BRIDGE REPLACEMENT - PPCB
NHSN-020-2(143)--2R-81

SAC COUNTY - DESIGN 116/216

EXAMPLE OF TITLE SHEET WITH 4 PLAN REVISIONS.

REVISION EXAMPLE

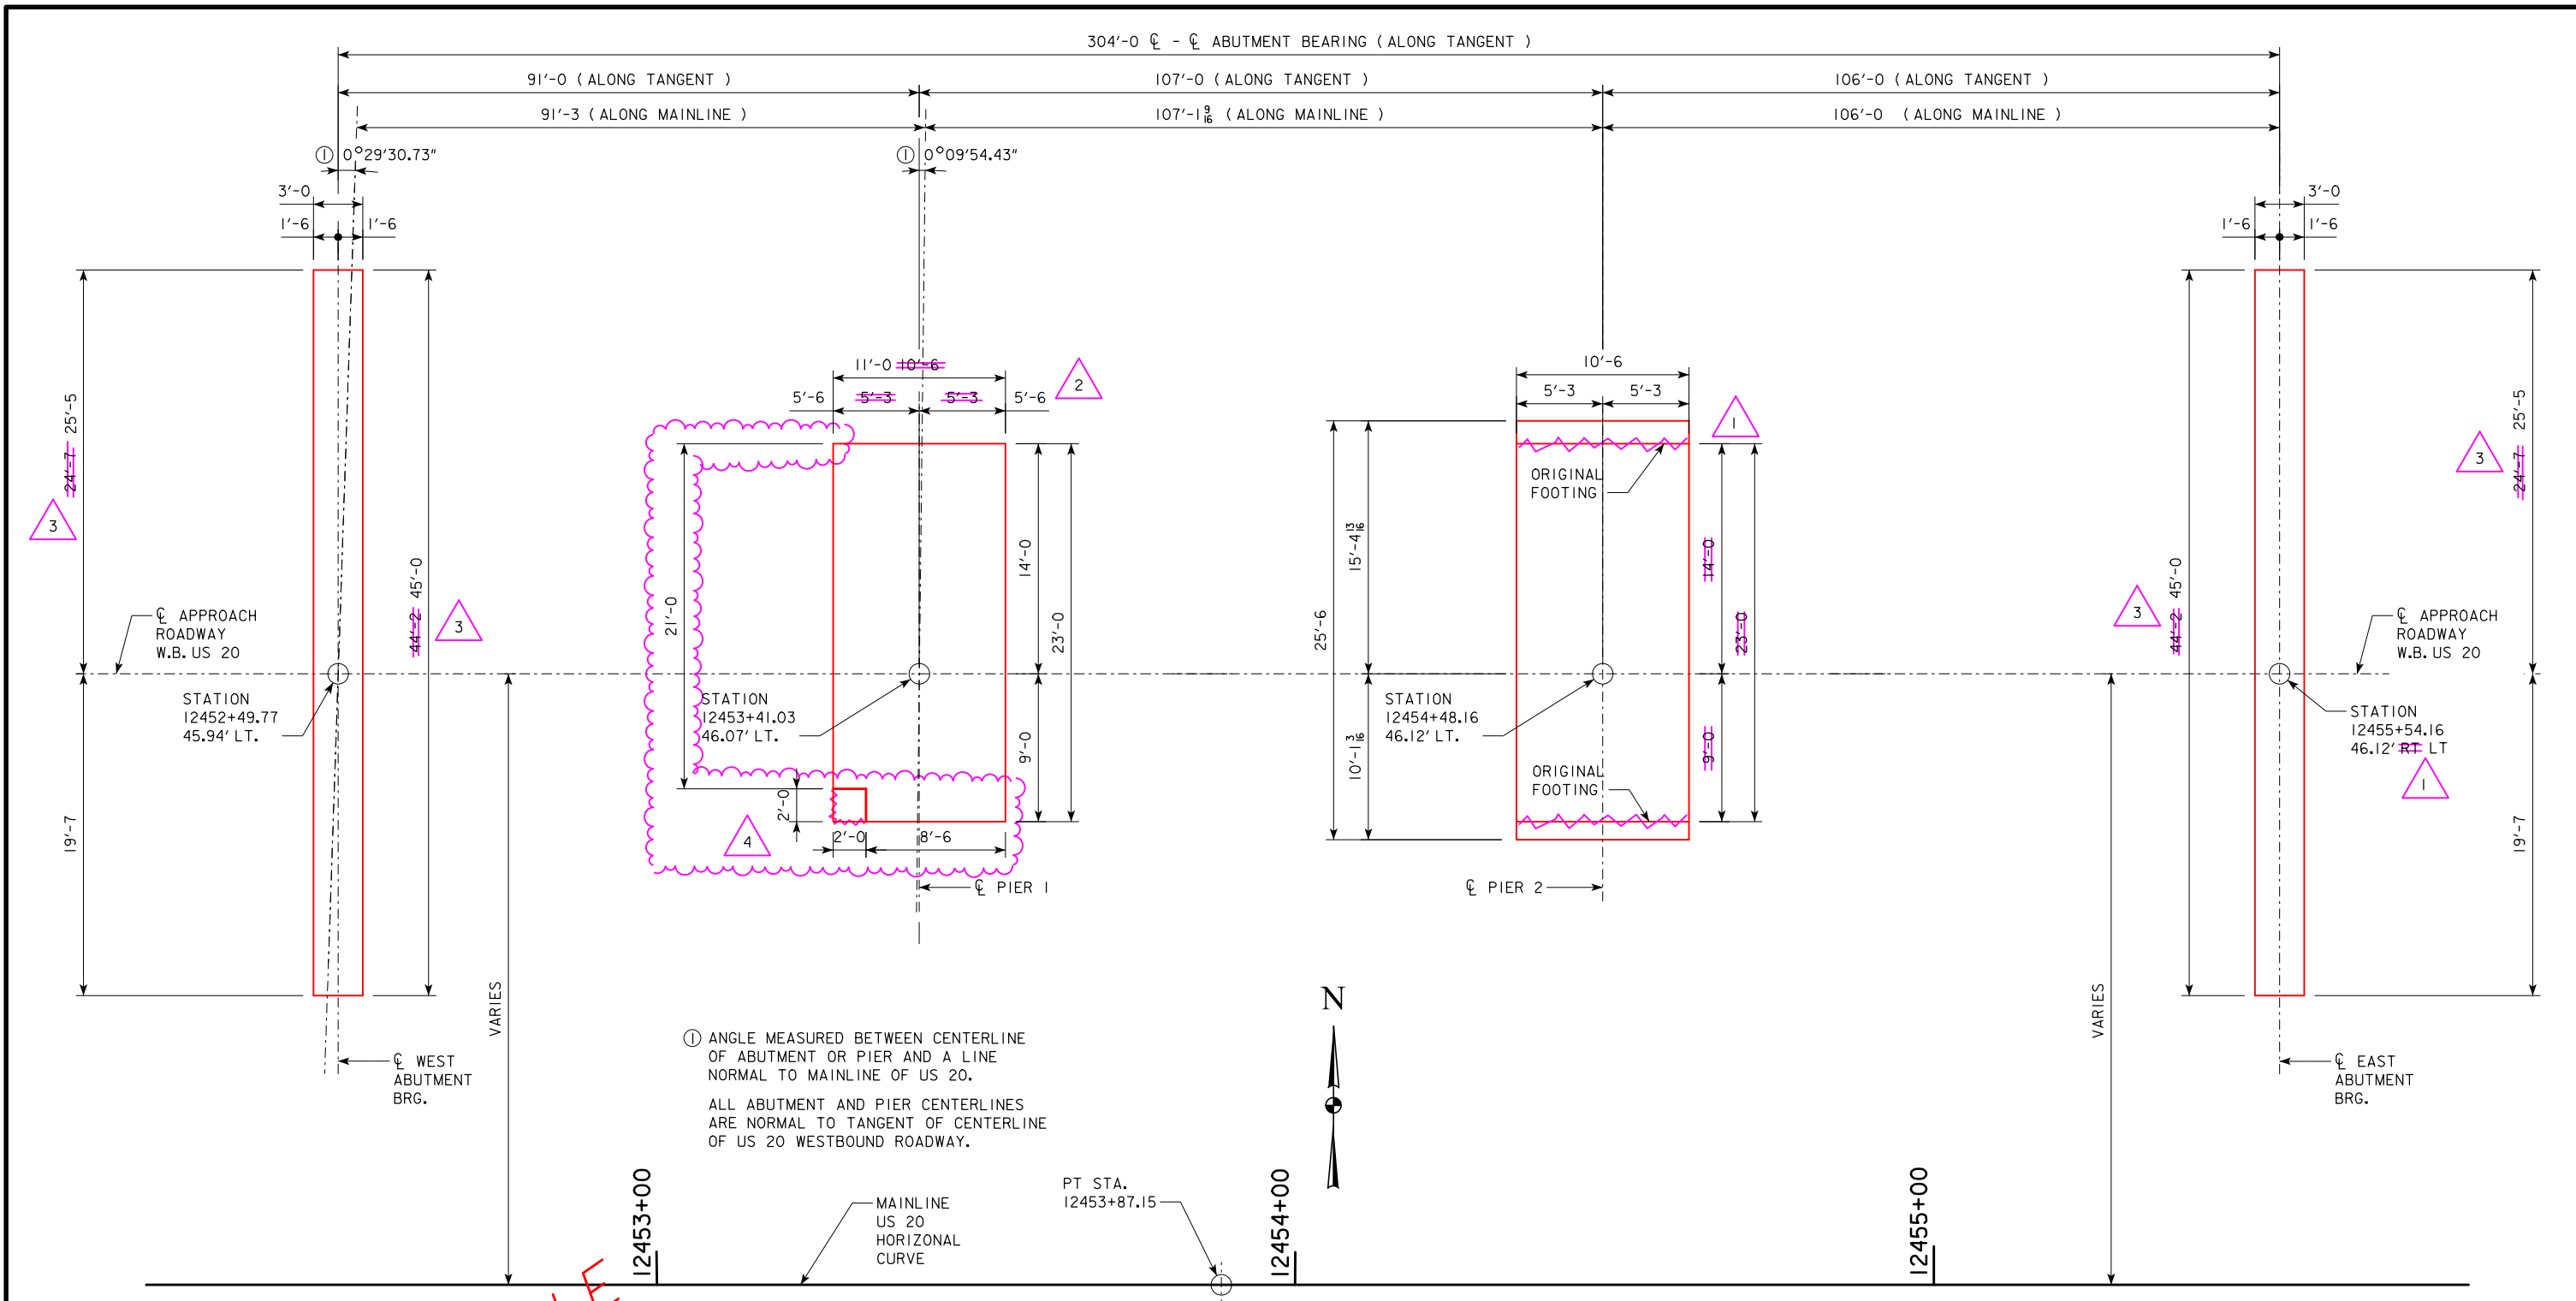
△ 2 REVISD: 03-27-2017 CHANGED STRUCTURAL CONCRETE (BRIDGE), PILES STEEL HP10x57 AND REINFORCING STEEL QUANTITIES. ADDED ITEM NO. 19.
 REASON: PIER 2 FOOTING MISPLACED 1.4 FT. NORTH OF PLAN ALIGNMENT DUE TO CONSTRUCTION SURVEY ERROR.

△ 3 REVISD: 04-11-2017 CHANGED STRUCTURAL CONCRETE (BRIDGE), PILES STEEL HP10x57 AND REINFORCING STEEL QUANTITIES. ADDED ITEM NO. 19.
 REASON: PIER 2 FOOTING MISPLACED 1.4 FT. NORTH OF PLAN ALIGNMENT DUE TO CONSTRUCTION SURVEY ERROR.

△ 1 REVISD: 03-09-2017 CHANGED STRUCTURAL CONCRETE (BRIDGE), PILES STEEL HP10x57 AND REINFORCING STEEL QUANTITIES. ADDED ITEM NO. 19.
 REASON: PIER 2 FOOTING MISPLACED 1.4 FT. NORTH OF PLAN ALIGNMENT DUE TO CONSTRUCTION SURVEY ERROR.

STAKING DIAGRAM

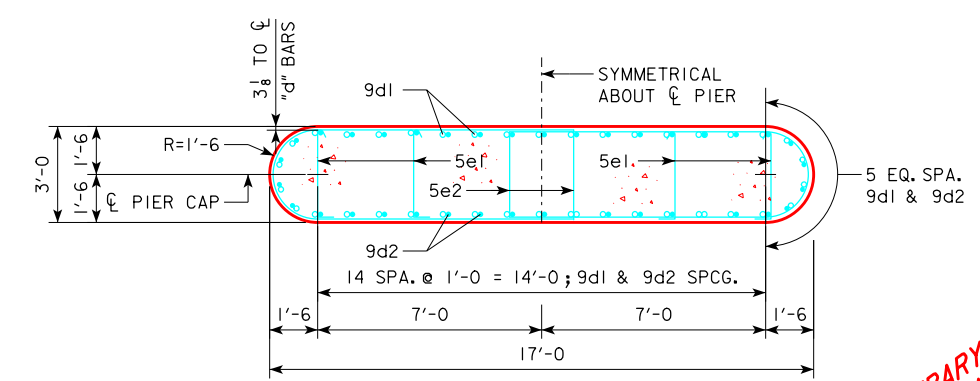
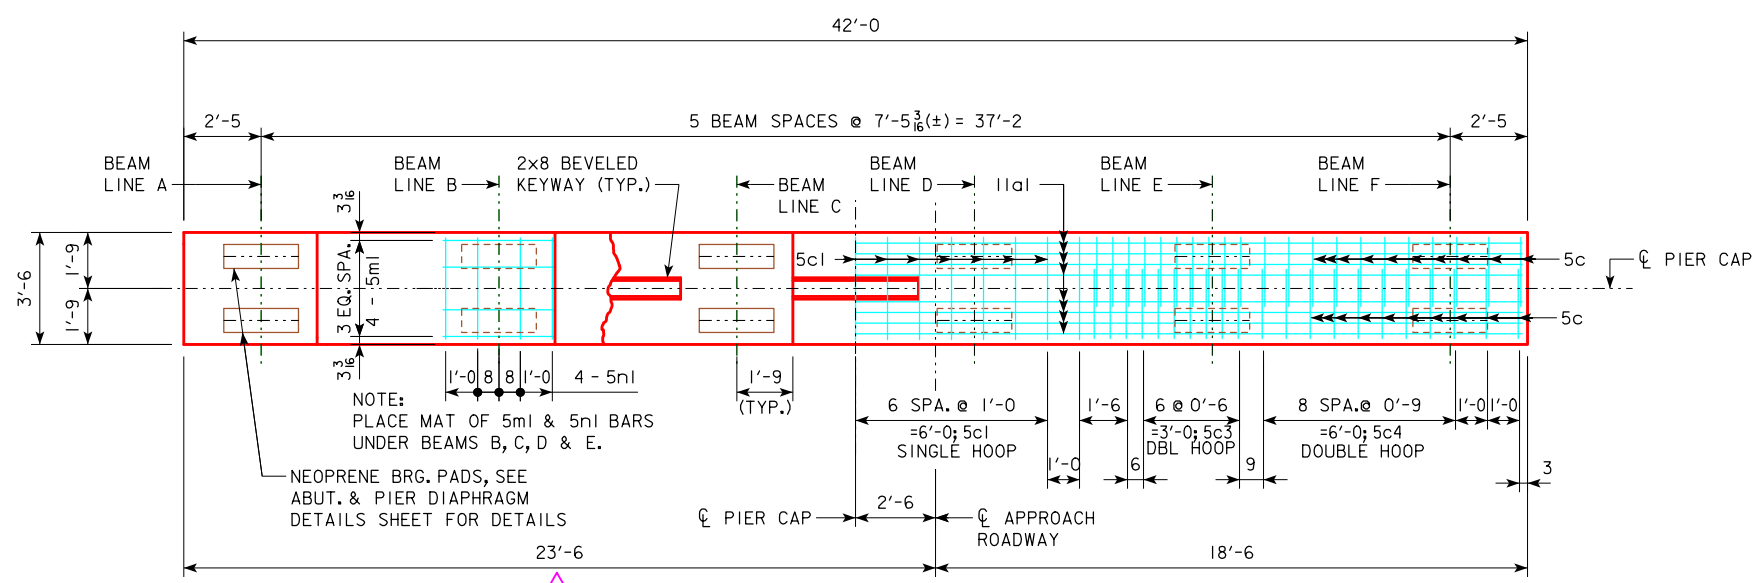
- ④ REVISED: 04-15-2017 REMOVED 2'-0" x 2'-0" CORNER OF PIER 1.
 REASON: CORNER REMOVED TO ALLOW CLEARANCE FOR MSE WALL.
- ③ REVISED: 04-11-2017 LENGTHEN ABUTMENTS 10' TO THE NORTH.
 REASON: ADDED SIDEWALK TO BRIDGE.

- ② REVISED: 03-27-2017 CHANGED PIER 2 LOCATION.
 REASON: PIER 1 FOOTING SIZE CHANGE DUE TO SURVEY ERROR.
- ① REVISED: 03-09-2017 CHANGED PIER 2 LOCATION.
 REASON: PIER 2 FOOTING MISPLACED 1.4 FT. NORTH OF PLAN ALIGNMENT DUE TO CONSTRUCTION SURVEY ERROR.

PIER I PIER DETAILS

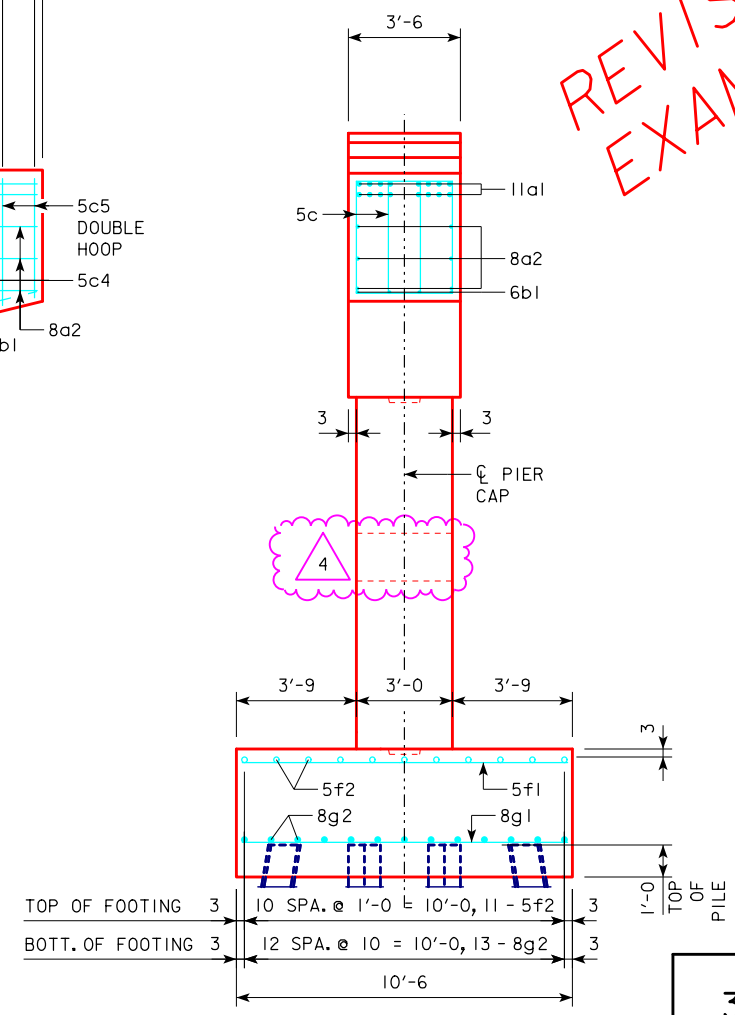
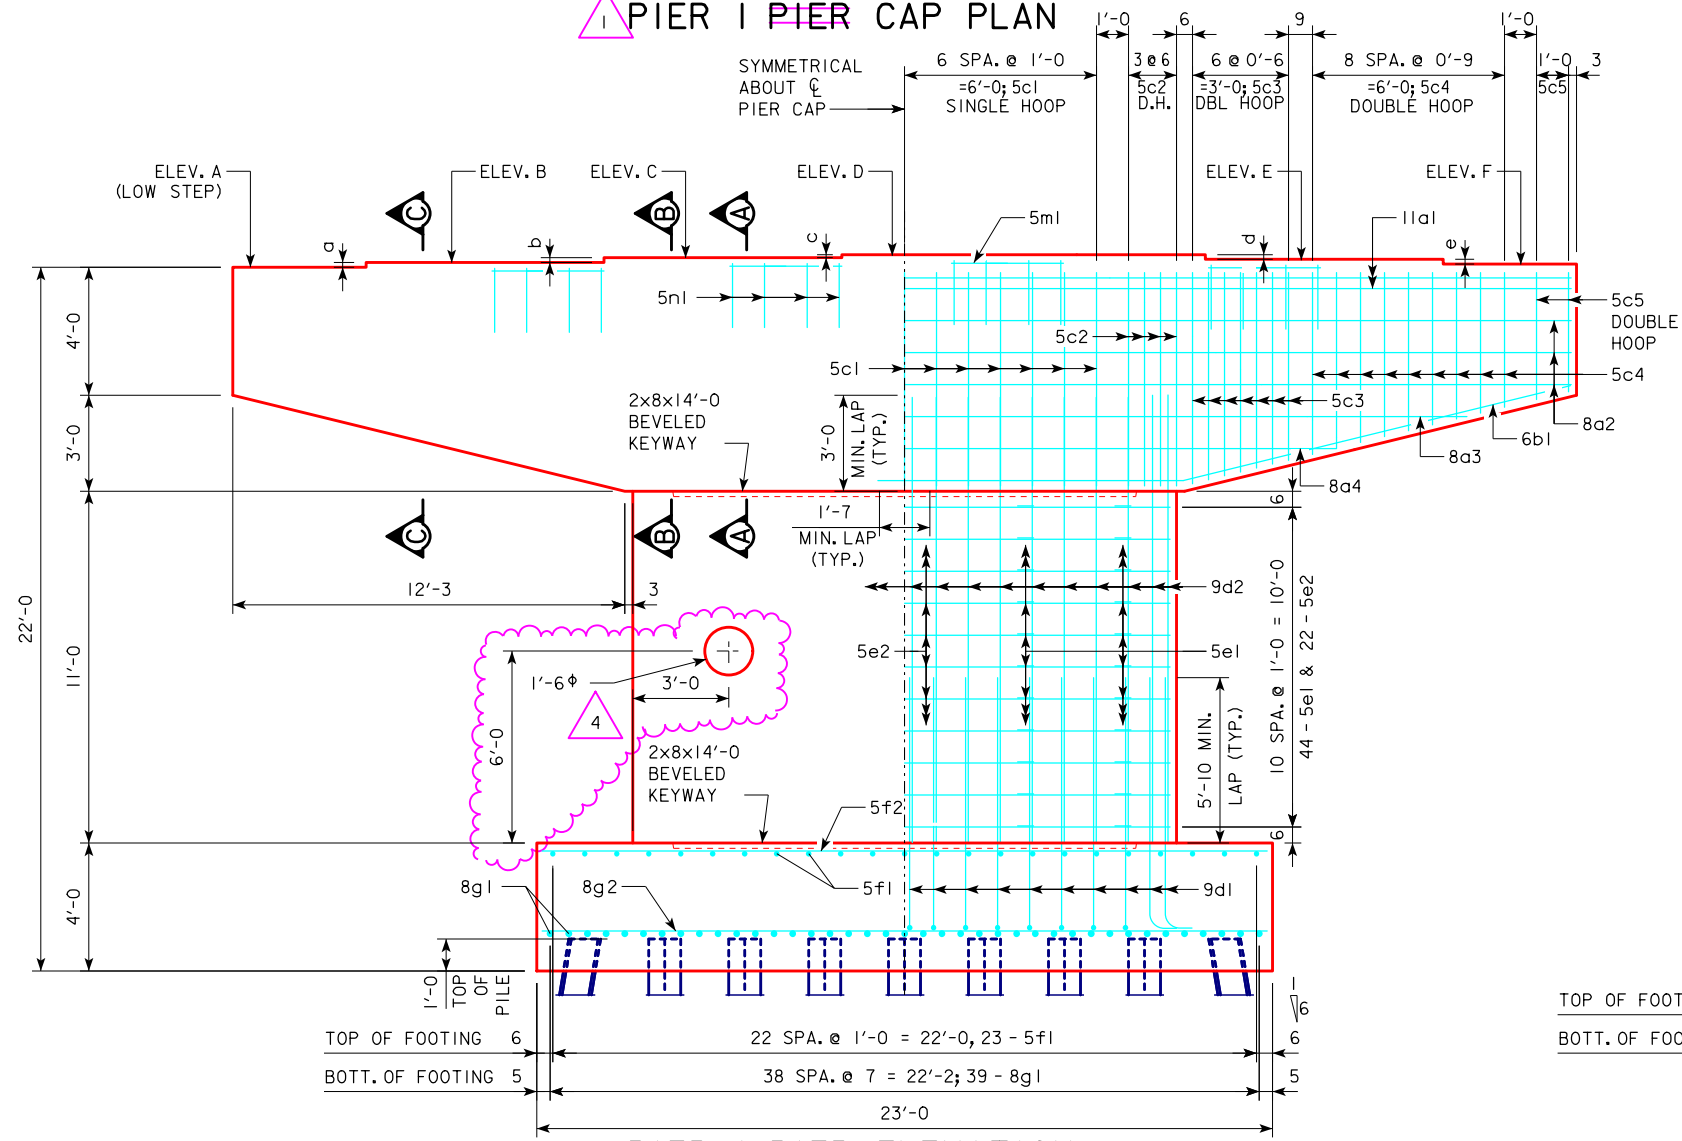
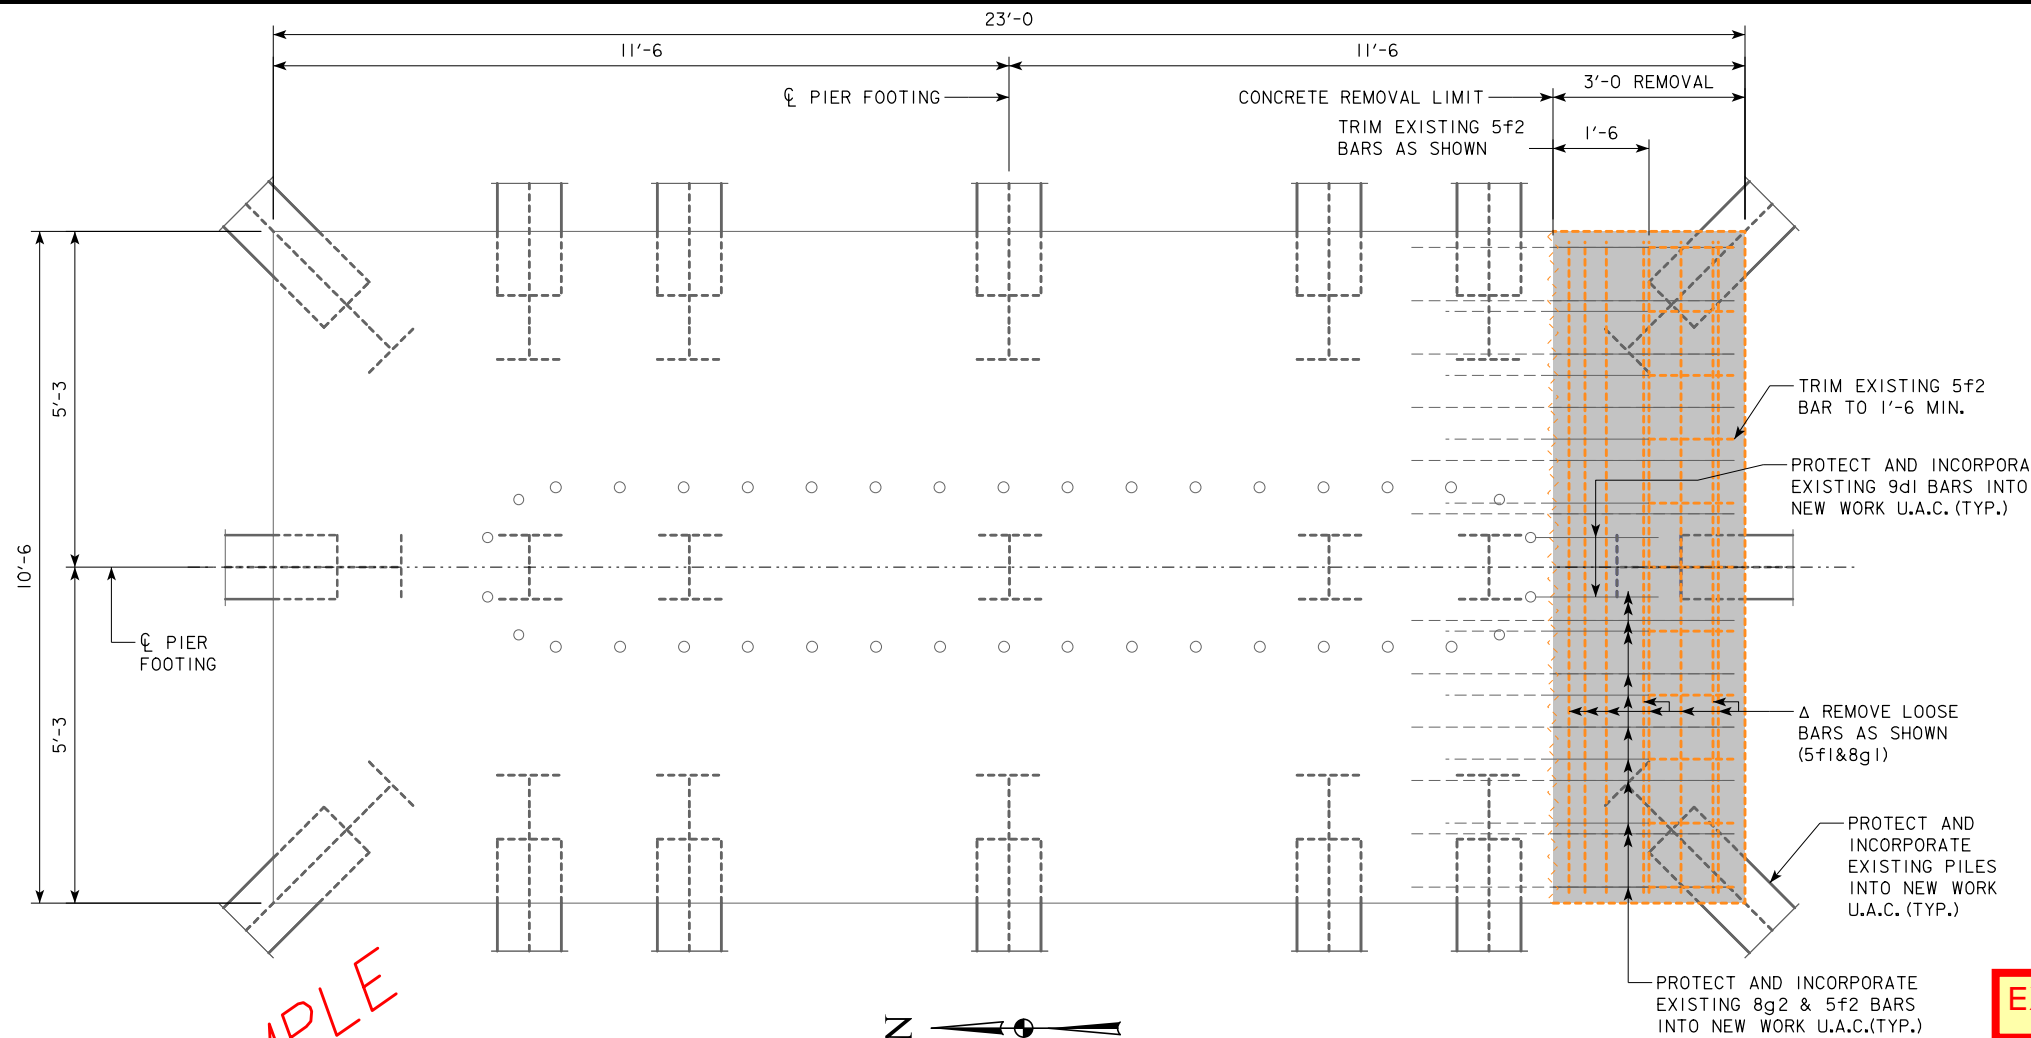
4 REVIS: 04-15-2017 ADDED 1'-6" HOLE TO PIER 1 COLUMN.

REASON: LOCATION FOR WATER MAIN PASS THROUGH.

2 REVIS: 03-27-2017 CHANGED PIER 1 POINT AND STEP ELEVATIONS.

REASON: DUE TO CONSTRUCTION SURVEY ERROR.

1 REVIS: 03-09-2017 CHANGED TYPICAL PIER TO PIER 1 AND ELEVATION NOTE TO LOOKING EAST.

REASON: PIER 2 FOOTING MISPLACED 1.4 FT. NORTH OF PLAN ALIGNMENT DUE TO CONSTRUCTION SURVEY ERROR.
